ADDENDUM # 4

Re: INVITATION FOR BIDS: 20-076-LS Freedom Park Phase 3

Questions and Answers

FREEDOM PARK PHASE 3

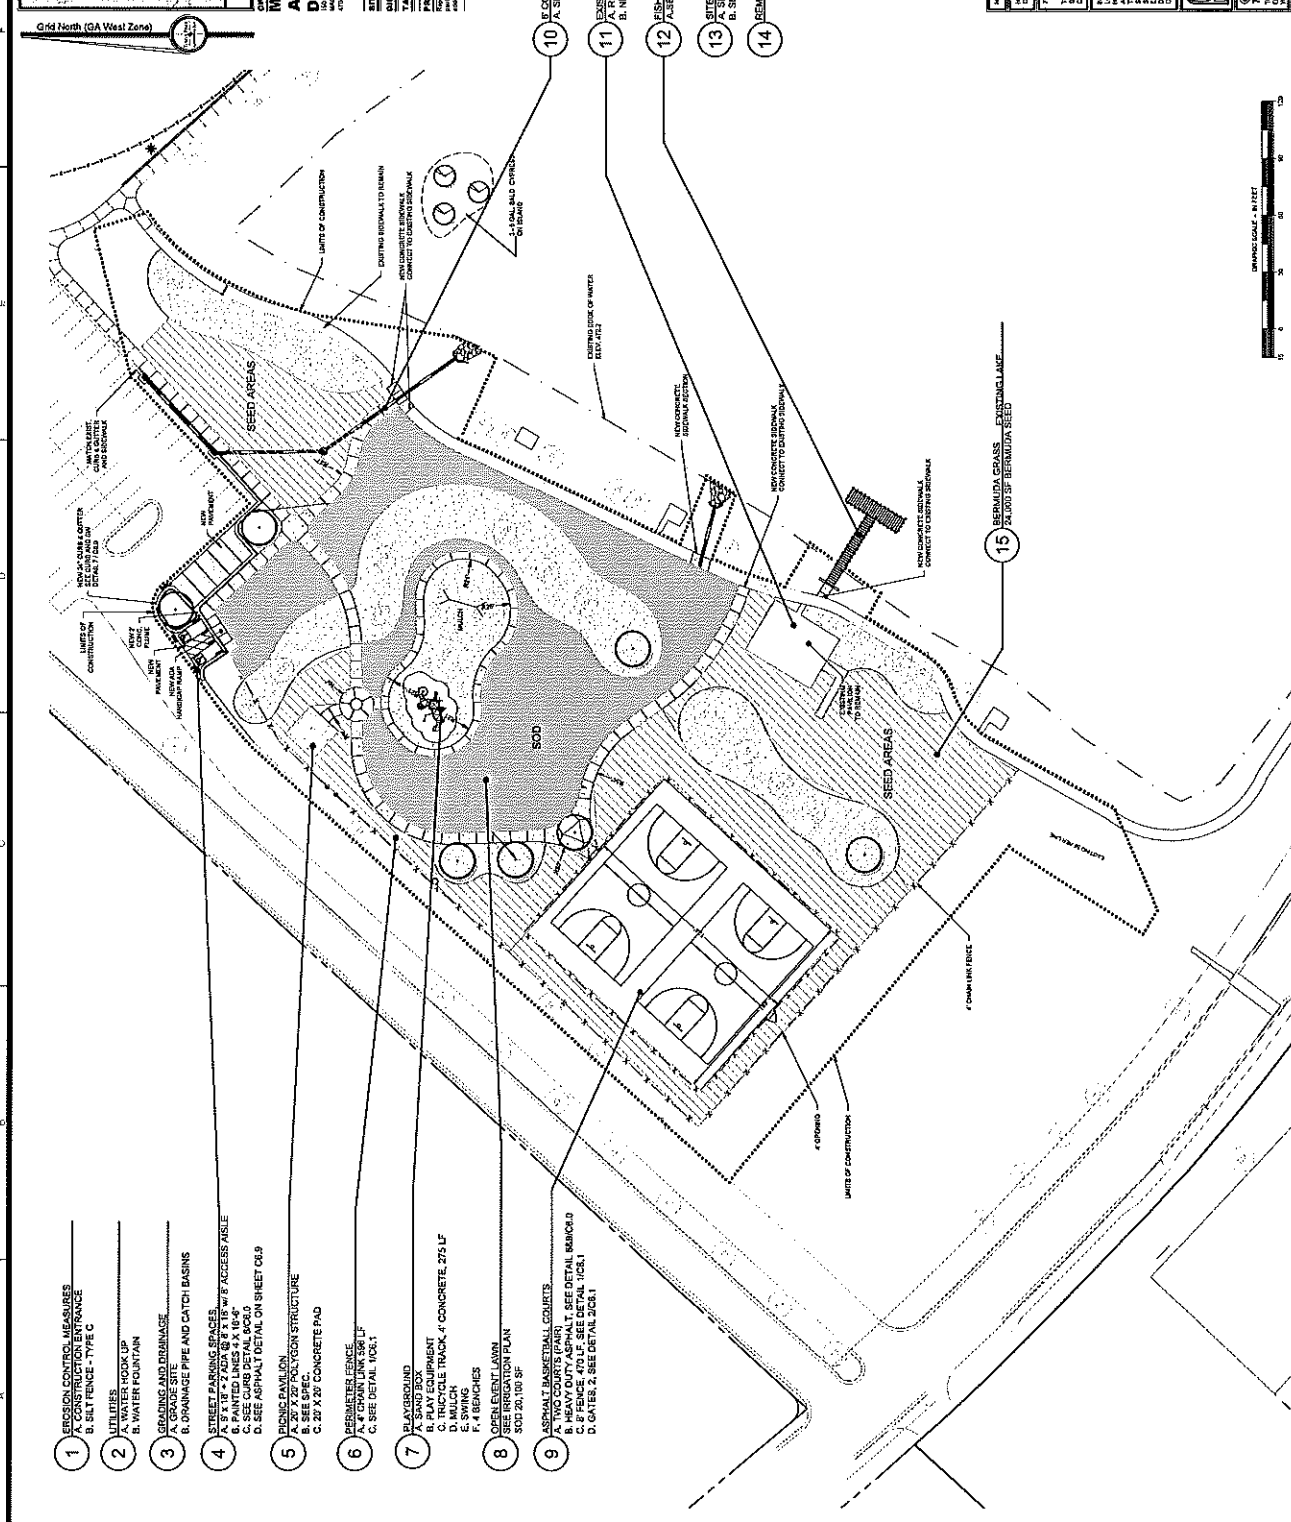
See attached Sod Plan.
